Savannah River
Remediation

NRC Salt Waste Monitoring Open Item Status

April 26, 2011

SRR-CWDA-2011-00043

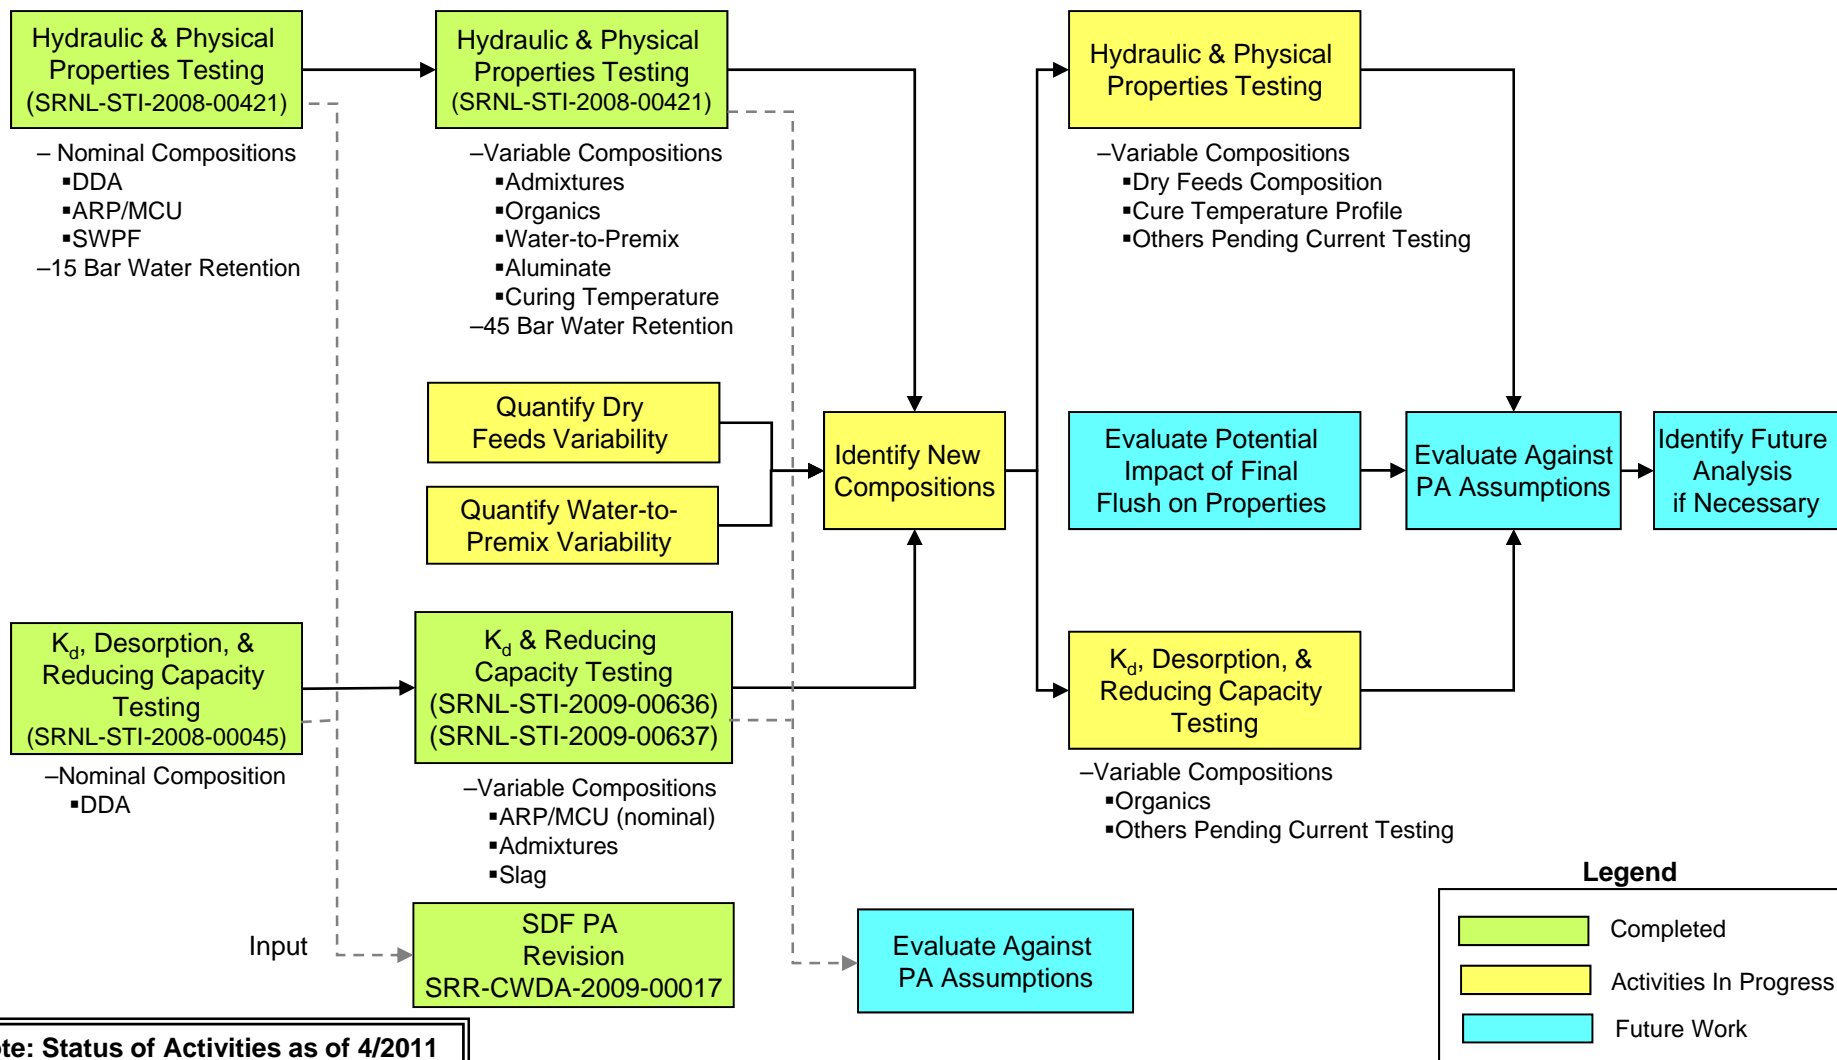
- **Issue**

- *At the SRS Saltstone Facility, DOE should demonstrate that intra-batch variability, flush water additions to freshly poured saltstone grout at the end of each production run, and additives used to ensure processability are not adversely affecting the hydraulic and chemical properties of the final saltstone grout. DOE should show that the hydraulic and chemical properties are consistent with the assumptions in the waste determination or show that any deviations are not significant with respect to demonstrating compliance with performance objectives.*

- **NRC Question**

- *What cure temperatures have been observed since 2007 and what is the anticipated cure temperature based on the increase in aluminate concentration?*

- Simulant variations continue to be prepared and tested (see status chart) for properties of hydraulic conductivity, porosity, bleed, set time, young's modulus and moisture characteristic curves.
 - New programmable oven purchased by SRNL in preparation for testing which will simulate cure temperature profiles of field emplaced saltstone.

Total Scheduled	27
Prepared	24
Tested	17

- **SRS Response**

- SRS has no specific plans to evaluate the impact of aluminate on cure temperature.
- Cure temperature profiles from saltstone production are being assembled and will be evaluated for use in subsequent testing.
 - Note: Cure temperature as a function of time may be as important to overall saltstone performance as the maximum data point recorded.

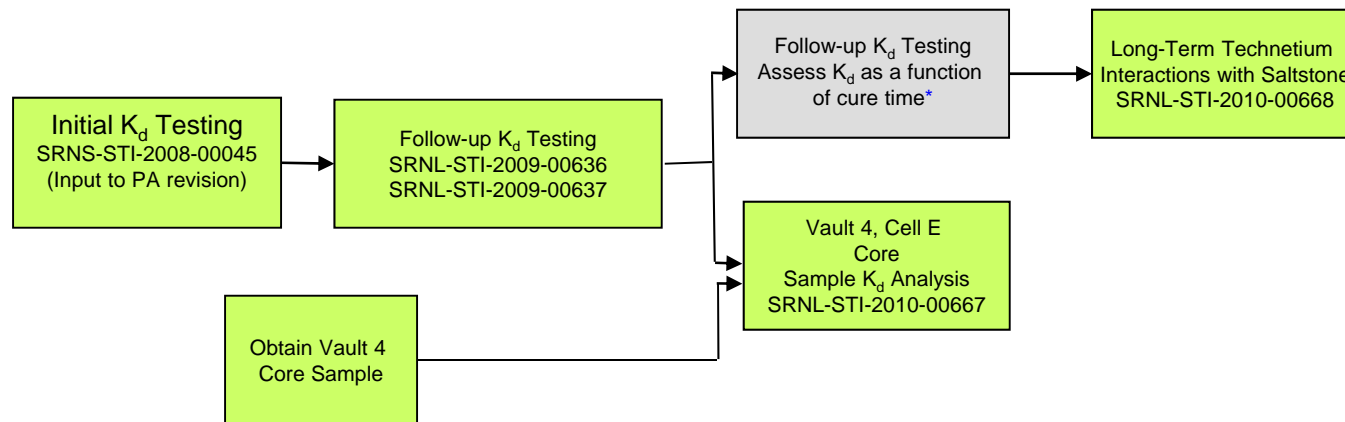
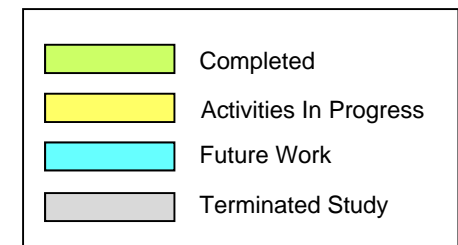
- **Issue**

- *At the SRS Saltstone Facility, DOE should demonstrate that (1) technetium-99 in salt waste is converted to its reduced chemical form in saltstone grout during the curing of saltstone grout, and is thereby strongly retained in saltstone grout, and (2) the sorption of dissolved technetium-99 onto saltstone grout and vault concrete is consistent with K_d values for technetium-99 that were assumed in the performance assessment.*

*Determined analytical methodology (glovebag) was ineffectual. Desired experimental conditions were achieved and documented in SRNL-STI-2010-00668 (glovebox).

- **SRS Status**
 - **Complete; Propose Closure**
- **Update**
 - Testing of K_d values for emplaced saltstone is complete.
 - Laboratory testing of saltstone simulants in an oxygen free environment is complete.
 - Emplaced Saltstone displays teal color indicative of reducing (and oxygen free) conditions within saltstone.

- Follow-up laboratory testing in oxygen free environment, as well as a more extensive literature review, support K_d values of 1000 used in the modeling of saltstone.
- Testing of K_d values as a function of curing time for saltstone simulants was discontinued due to limited ability to reproduce a low oxygen environment capability and the clear need for this environment to represent field conditions.
